MEETING AGENDA

Appearance Commission

Village of Homewood

Topic: Case 26-05: Sign Variance, Dynamite Shrimp @ 18719 Dixie Highway

MOCK-UP

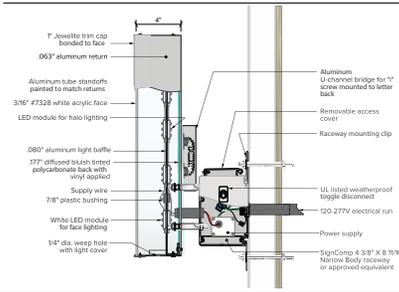
The proposed sign is an internally-illuminated aluminum cabinet sign with colored translucent sign faces. The proposed sign will include LED illumination. The proposed sign has a total area of 63 square feet. The proposed sign has a maximum width of 110 inches in width and a maximum height of 82 inches. The proposed sign is designed to display the logo of the business. The proposed sign will have a maximum height from grade of approximately 17 feet, and project approximately 11 inches from the wall surface of the building.

The sign is also significant taller than other signs already constructed on the commercial building. All other signs are horizontal in orientation, with heights between 1-2 feet. Other

signs on the building consist of 1-2 rows of lettering in a horizontal patterns along existing sign raceways on the building. The proposed sign is 7' 10" in height, which is 5' 10" taller than the next tallest sign on the building (Cold Stone Creamery, 2 feet in height).

Staff recommends a reduction in proposed sign area to meet this standard and to ensure conformance with other signs constructed at the Southgate Business Center.

- 1. Wall, ground, and identification signs shall be part of the architectural concept. Size color, lettering, locations, and arrangement shall be harmonious with the building design, and shall be compatible with signs on adjoining buildings. **Not met.*** The proposed sign is substantially larger than other signs on the same multi-tenant commercial building and on adjacent buildings in the Southgate business district. These adjacent signs include signs for businesses in tenant spaces 2-3x larger than the proposed business.

- 3. Every sign shall be scaled and designed so as to conform with relationship to buildings and surrounds. **Not met.*** The sign is significantly larger than surrounding signs on the same building. The sign is much taller (7' 10") than other signs nearby (1' – 2' in total height). The sign is not in scale with surrounding signs, particularly when vertical scale is considered.

1. The applicant shall revise sign drawings to reduce the total wall sign area to 40 square feet.
